Public Works Department – Engineering Division

ADDENDUM NO. 4

PROJECT 5067 WTP FILTER IMPROVEMENTS AND HYPOCHLORITE CONVERSION

DWG. NO.
S302

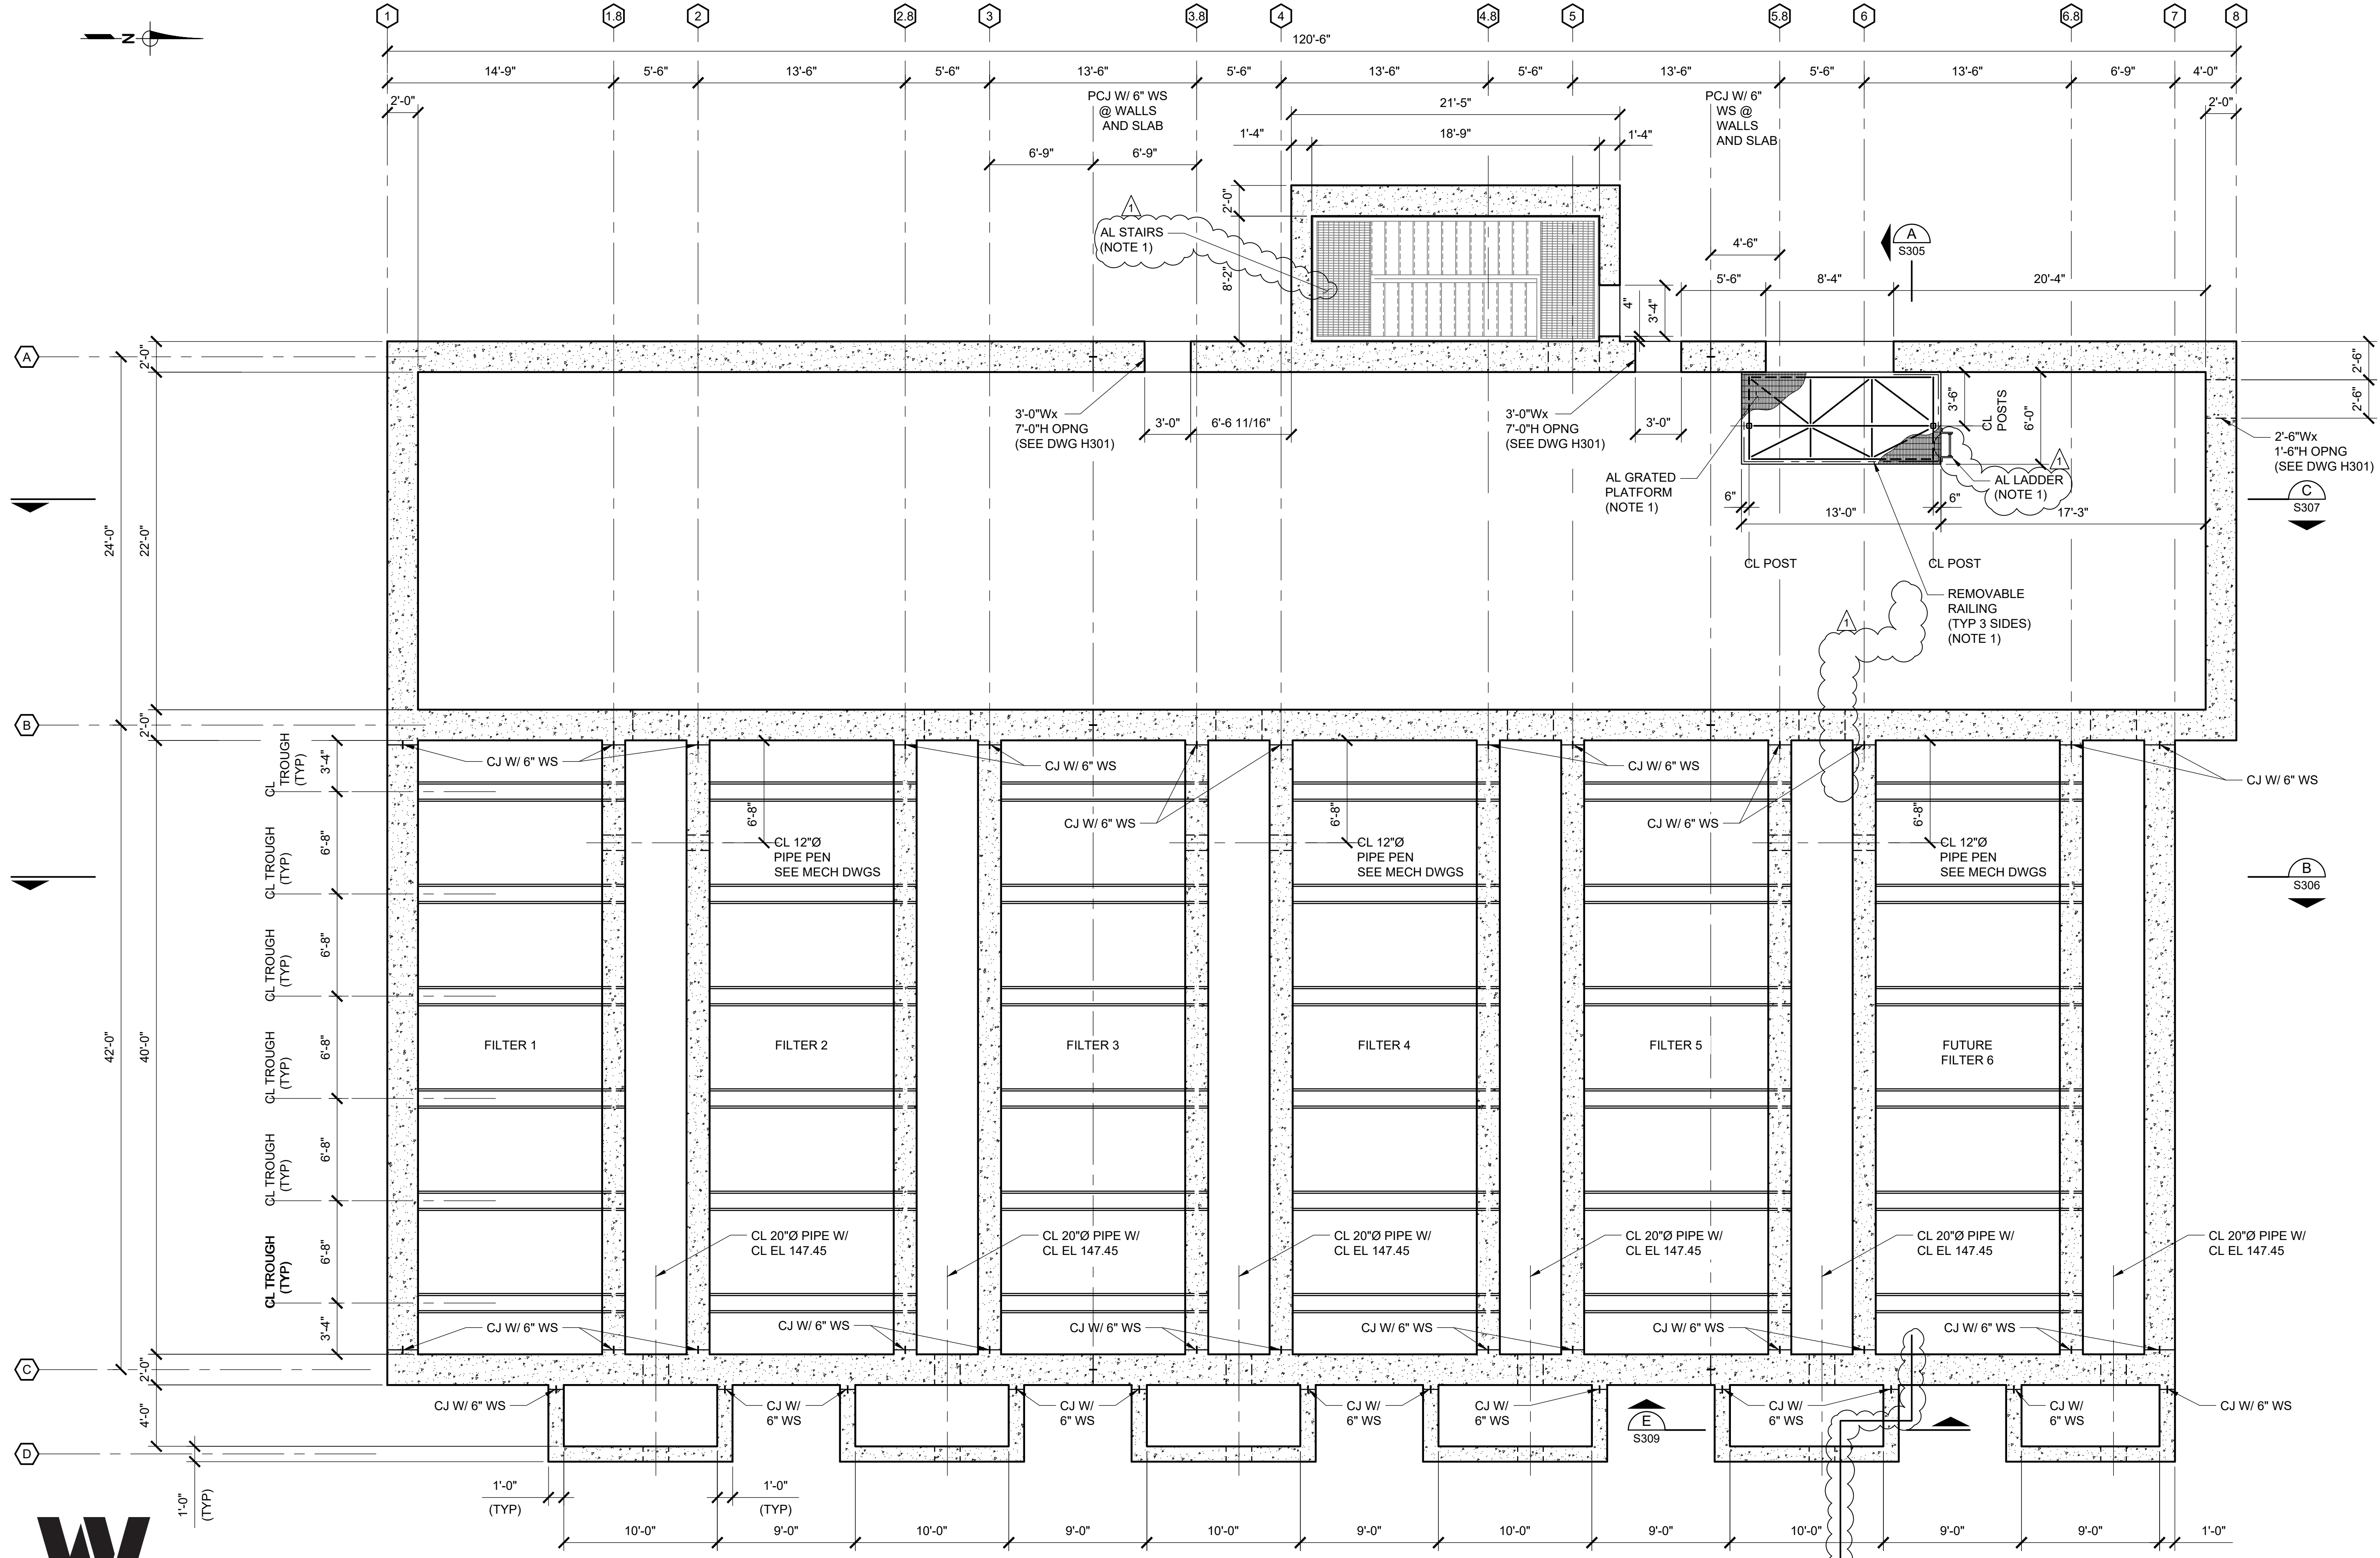
24. Replace Drawing S302 with the attached updated drawing S302.
25. Replace Drawing S310 with the attached updated drawing S310.
26. Replace Drawing S643 with the attached updated drawing S643.

55. Rev 1 Drawing A102 provided in Addendum 3 added Keynote 14 which says, "Metal Ladder Per Structural Drawings." The ladder shown in the Architectural plan view on the north side of the EL. 142 Platform is not shown on the Structural Drawings, or the Rev 1 Section on A108 provided in Addendum 3. The addition of this ladder is also not mentioned in A.1, Additions/Deletions/Revisions of Addendum 3. Please confirm the addition of the ladder, and if confirmed, provide a corresponding section view as well as an applicable detail for this Ladder. Detail 05561 provided in Addendum 3 requires connections to a vertical concrete surface @ 4'-0" OC max. which would not be possible at the Keynote 14 callout location.

Response: Metal ladder has been added to the structural drawings. See updated Structural drawings S301 and S302 in Item A.23 and A.24 above. The ladder is a deferred submittal that requires the Contractor to submit engineering design calculations and details that are prepared, stamped and signed by a California licensed civil or structural engineer.
